Docket Item # 1  
BAR CASE # 2011-0072

BAR Meeting  
April 27, 2011

**ISSUE:** Fence Construction and Waiver of Section 7-202 (Height Requirement)  
**APPLICANT:** Henry and Jessica Almond  
**LOCATION:** 419 North West Street  
**ZONE:** RB/ Residential Townhouse Zone

**BAR CASE #2011-0072**

Figure 2: Site Plan - Proposal

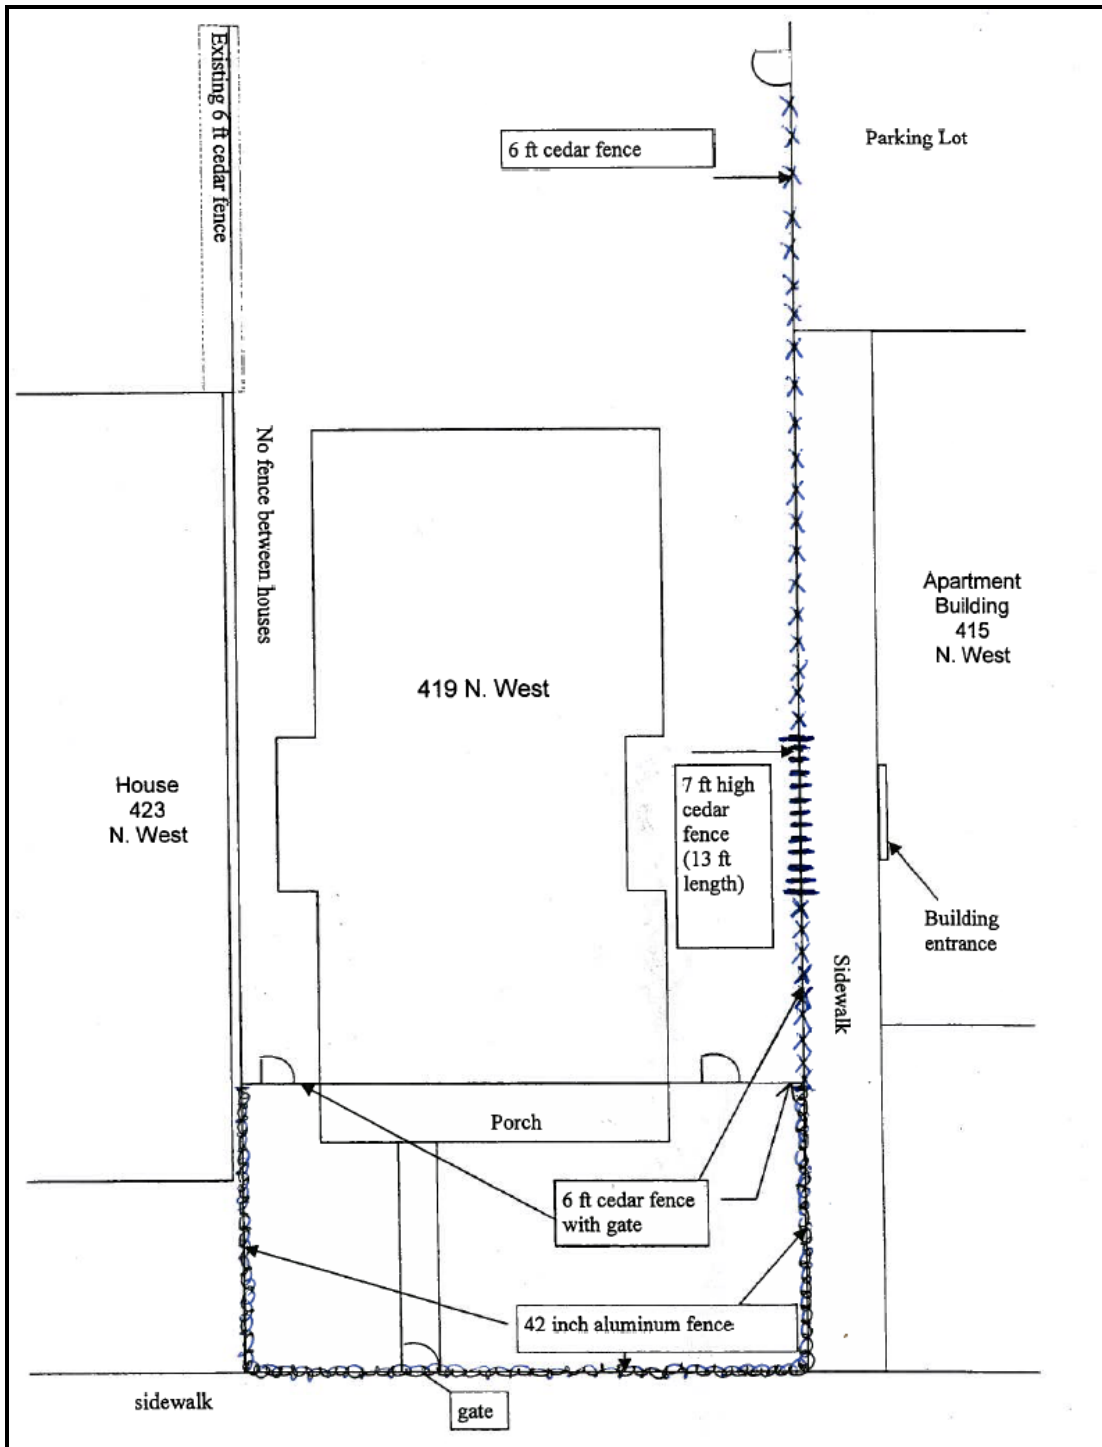
The applicant is proposing a 6 foot cedar fence with gate to extend from both sides of the dwelling's front elevation. Staff recommends that the segment of the fence to be extended from the right elevation be recessed back 6 feet behind the front facade of the dwelling into the side yard in order to preserve the view shed of the garden apartment building at 415 North West Street. The entrance to this apartment building is adjacent to the south side elevation of the dwelling and includes many character-defining features such as 15-light door, side lights, and a prominent door surround. Staff believes that the entrance to this neighboring building is a significant detail, which should remain visible from the existing streetscape for aesthetic and security reasons. Staff has discussed the modification to the submittal with the applicant and the applicant has verbally agreed to this revision to their proposal.

Staff recommends the approval of the Certificate of Appropriateness and the Waiver of Height Requirement with the condition that the 6 foot cedar fence with gate on the south side yard be recessed back 6 feet from the face of the dwelling in order to preserve the view shed of the adjacent garden apartment building.

1. That the cedar fence commences 6 feet from front elevation, adjacent to the electric meter on the side elevation of the house, in order to preserve the view shed of the neighboring building's entrance.
2. That the aluminum fence to be installed in the front yard not exceed 3'-6" feet high.
3. That all new fencing to be installed must be located entirely on the subject property.

Figure 3: Plat – Locations of Existing Fence and Property Lines

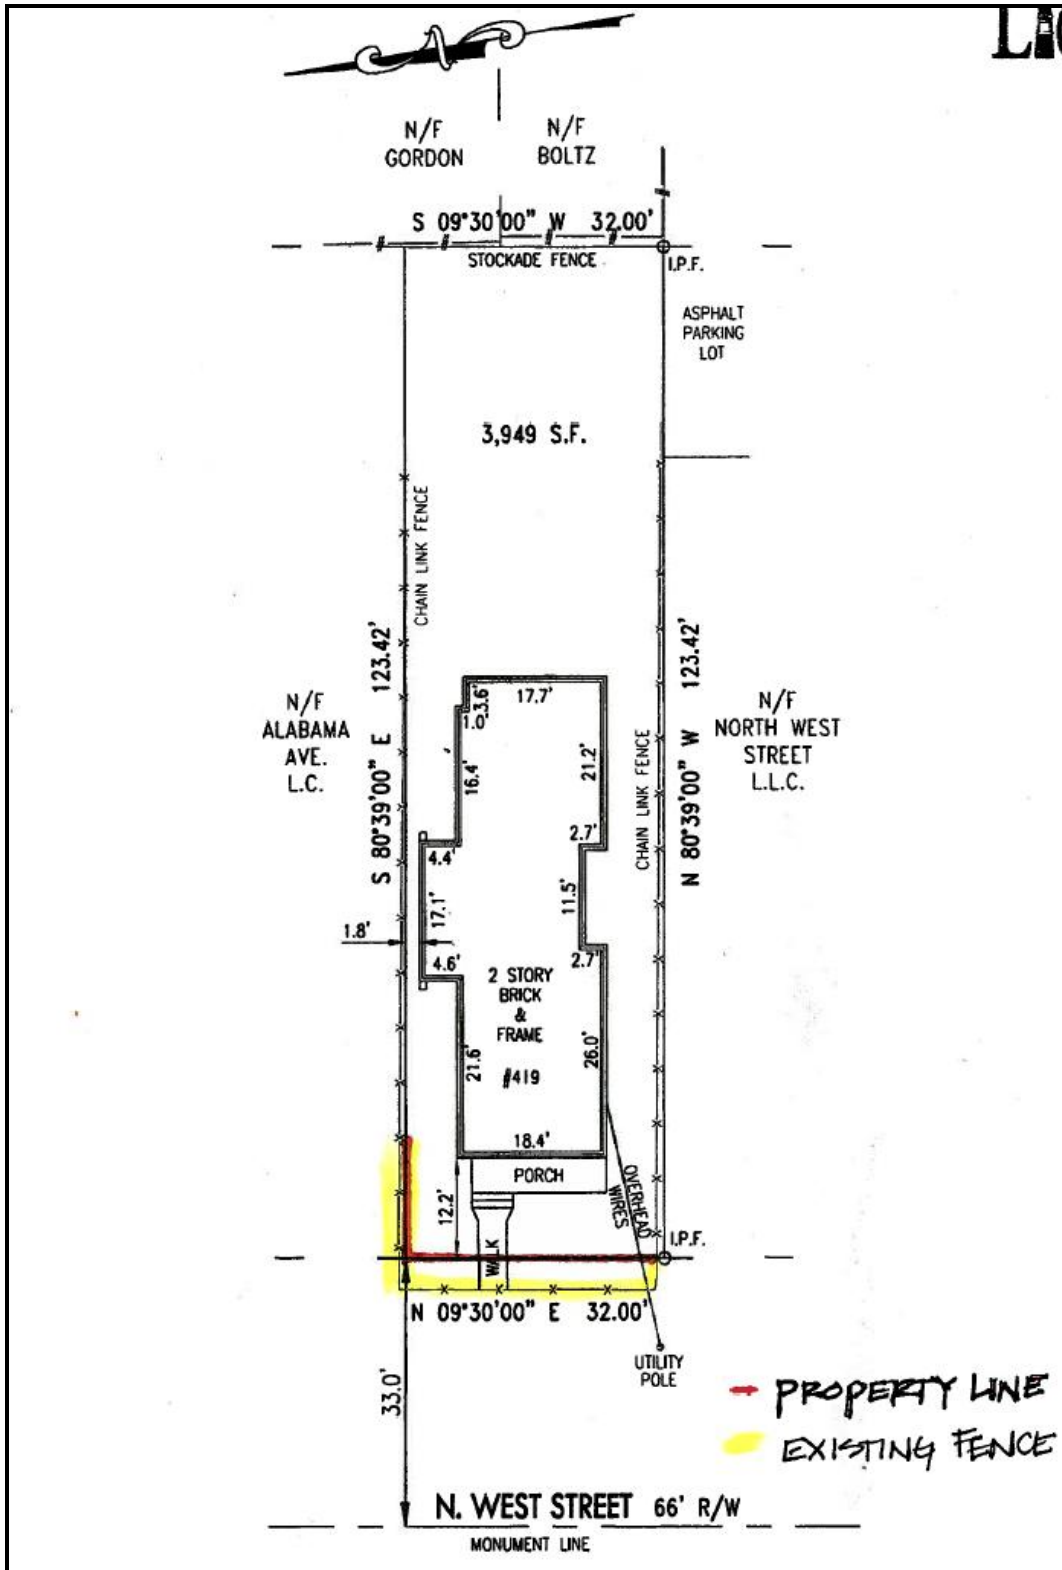
The Zoning and T&ES Staff advise that the existing fence segments along the northern and western property lines must be removed from the public right-of-way. If the applicant wishes to install the new fence in its current location, as shown on the plat (See Figure 3), the applicant will need to request an Encroachment, and defer the BAR decision.

All new fences must be located on the subject property. The existing front fence is located within the public right of way. Portions of the side and rear fence are located on adjacent properties. Relocate all replacement fences so they are on the subject property.

- C1. An Encroachment will be required for the front fence installation as it is within the public right-of-way. (Sec. 5-2-29) (T&ES)
- C-2 The applicant shall comply with the City of Alexandria's Solid Waste Control, Title 5, Chapter 1, which sets forth the requirements for the recycling of materials (Sec. 5-1-99). (T&ES)
